MEMORANDUM CH2MHILL

Evaluation of Trial Bunker Hill Mine Water Diversion

TO: Cami Grandinetti/USEPA

December 20, 2002

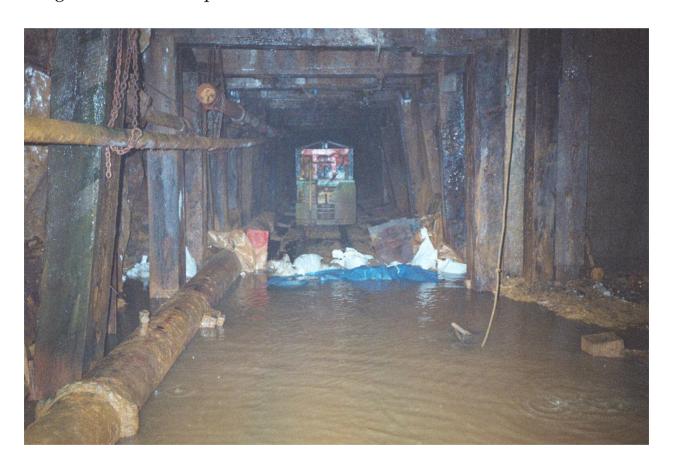
Looking downstream at back of trial diversion dam on 9 Level. The dam is constructed across the Kellogg Tunnel just past (north) of the Barney Switch. The dam is made from sandbags, boards, and plastic tarps. Additional sandbags, boards, and tarps are stored to the right of the photo. The depth of water behind the dam is about 2 feet on the sides, and about 3 inches above the rail in the middle. The flow being dammed is about 1550 gpm. About 50 gpm was leaking through the dam, although this could be readily reduced by another layer of sandbags on the downstream face. The dam would have to be increased in height for higher flows. The reported construction time was 30 minutes.

Photo 2

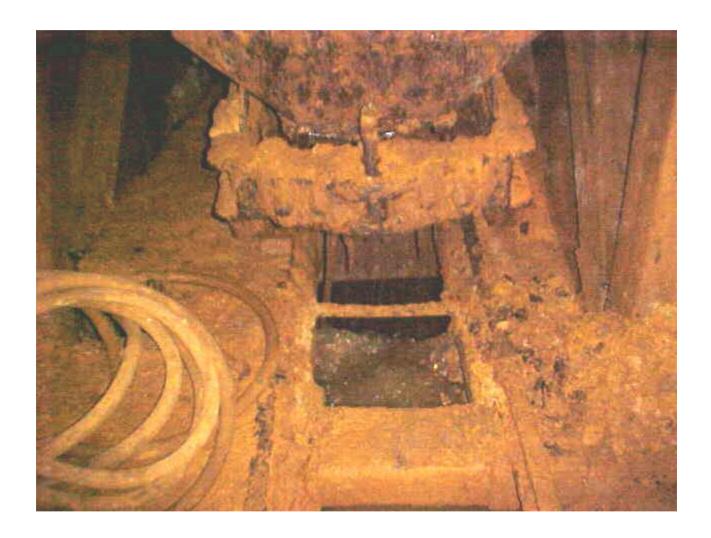
Looking upstream at the trial diversion dam.
